**PECOS DISTRICT
CONDITIONS OF APPROVAL**

OPERATOR'S NAME:	Cimarex Energy Company of Colorado
LEASE NO.:	NM-124663
WELL NAME & NO.:	Lynch 23 Federal Com #1
SURFACE HOLE FOOTAGE:	0330' FNL & 1830' FEL
BOTTOM HOLE FOOTAGE:	0330' FNL & 660' FEL
LOCATION:	Section 23, T. 20 S., R. 34 E., NMPM
COUNTY:	Lea County, New Mexico

Cross Section of a Typical Lead-off Ditch

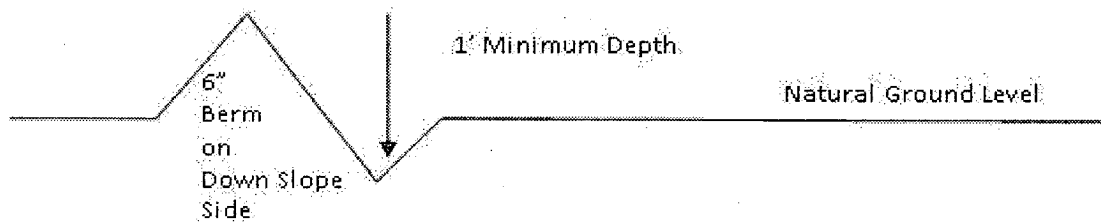
A typical lead-off ditch has a minimum depth of 1 foot below and a berm of 6 inches above natural ground level. The berm shall be on the down-slope side of the lead-off ditch.

All lead-off ditches shall be graded to drain water with a 1 percent minimum to 3 percent maximum ditch slope. The spacing interval are variable for lead-off ditches and shall be determined according to the formula for spacing intervals of lead-off ditches, but may be amended depending upon existing soil types and centerline road slope (in %);

Figure 1 – Cross Sections and Plans For Typical Road Sections

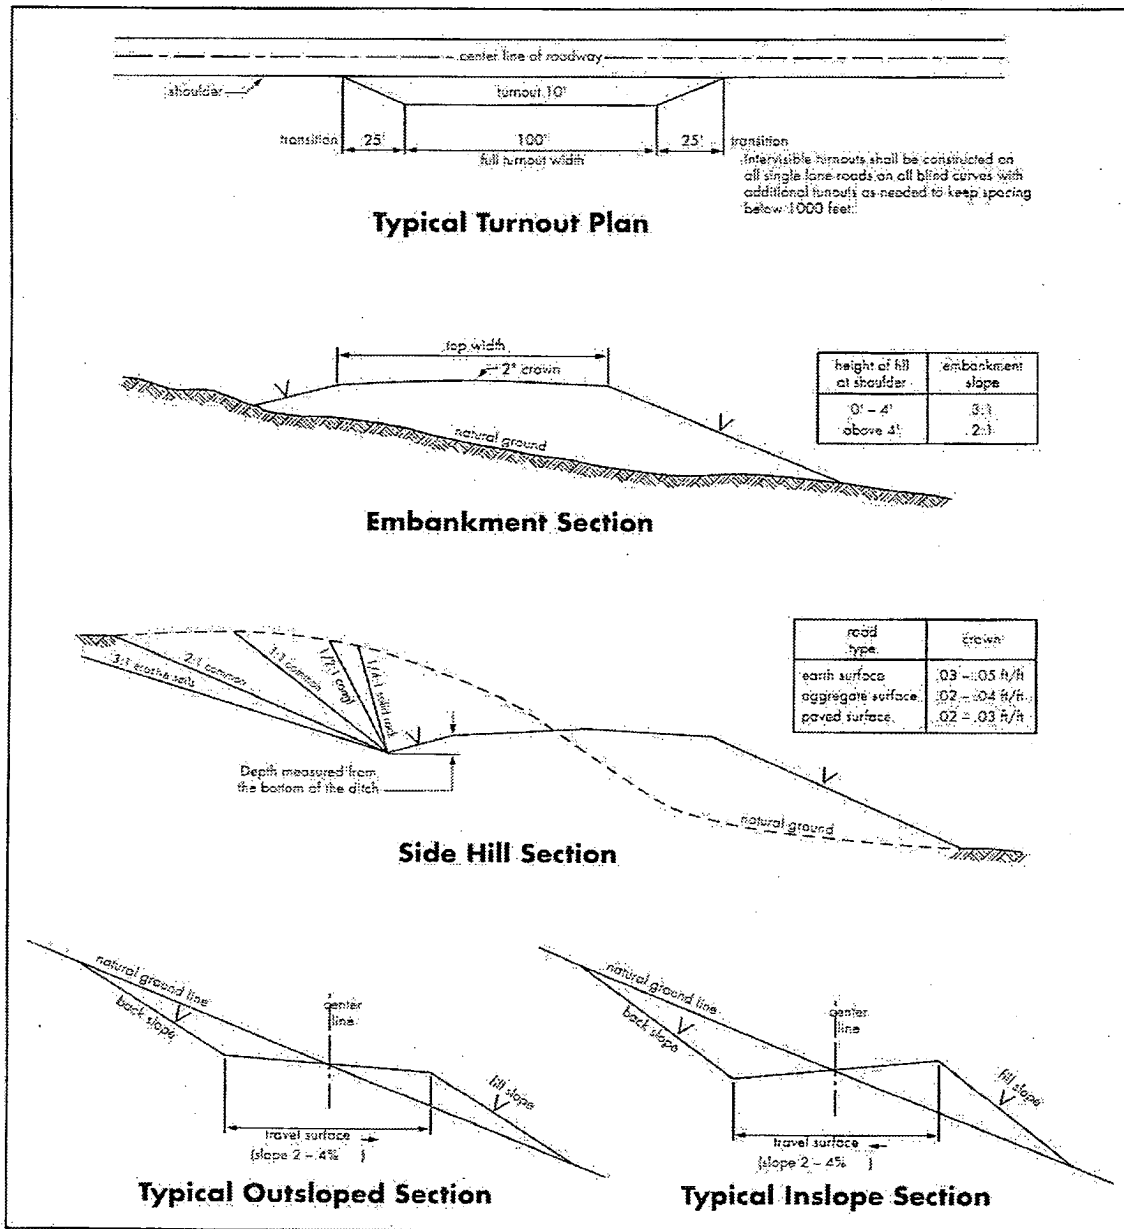
Crowning shall be done on the access road driving surface. The road crown shall have a grade of approximately 2% (i.e., a 1" crown on a 14' wide road). The road shall conform to Figure 1; cross section and plans for typical road construction.
